SERVICE LETTER

No. 650

Piper Aircraft Corporation

Inspection of Landing Gear Retraction and Flap Control
Transmission Assemblies

Flap Control Transmission Assembly

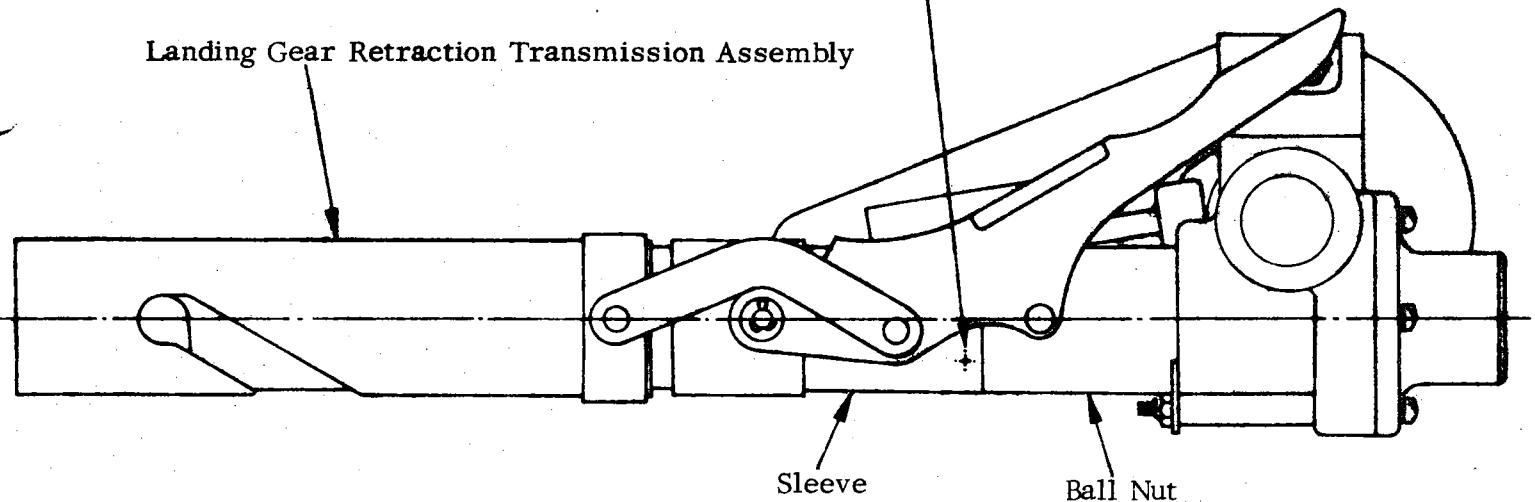
Sleeve must be staked at three points
(on circumference of sleeve) to prevent
separation of threaded joint.

1. Refer to the appropriate Service Manual and gain access to the flap control transmission (if installed) and the landing gear retraction transmission.
2. Inspect transmissions to determine if sleeve has been properly staked as shown on above sketch.
3. If the transmission sleeves have been properly staked, no further action is required.
4. If either of the transmission sleeves have not been staked, it will be necessary to remove the transmission from the airplane and stake as shown (sleeve must be tight against ball nut before staking). Use a center punch and carefully stake to a depth of .030 to .040 inches. Refer to the appropriate Service Manual for proper Removal and Installation Procedures.

- REFERENCE SERVICE LETTER NO. 650: Purpose II
Identification of Transmission Ball Screw;
Transmission serial numbers 919 thru 1068 inclusive.

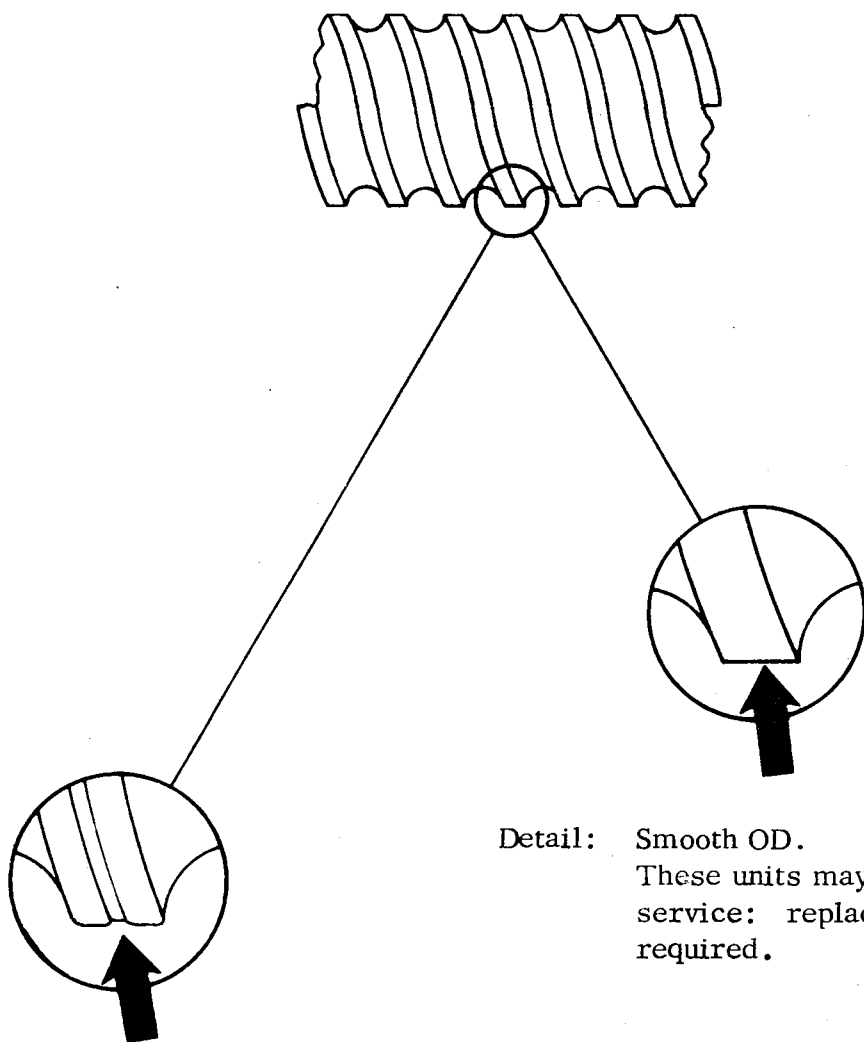
Subsequent to publication of Piper Service Letter No. 650, it has been determined that not all of the above referenced transmission assemblies require replacement. An inspection procedure has been provided by the manufacturer to determine if the transmissions referred to above need to be replaced. Details are specified below and on the sketch on the reverse side of this communication.

1. Expose the threaded ball screw portion of the transmission assembly to view.
2. With a magnifying glass, inspect the threads as specified on the sketch on the reverse side of this communication.
3. Refer to the "detailed" call-outs on the sketch to determine whether the transmission assembly must be replaced.
4. Refer to the balance of Piper Service Letter No. 650 for replacement material identification data.

Detail: Smooth OD.
These units may remain in
service: replacement not
required.

Detail: Grooved OD.
These units must be replaced.
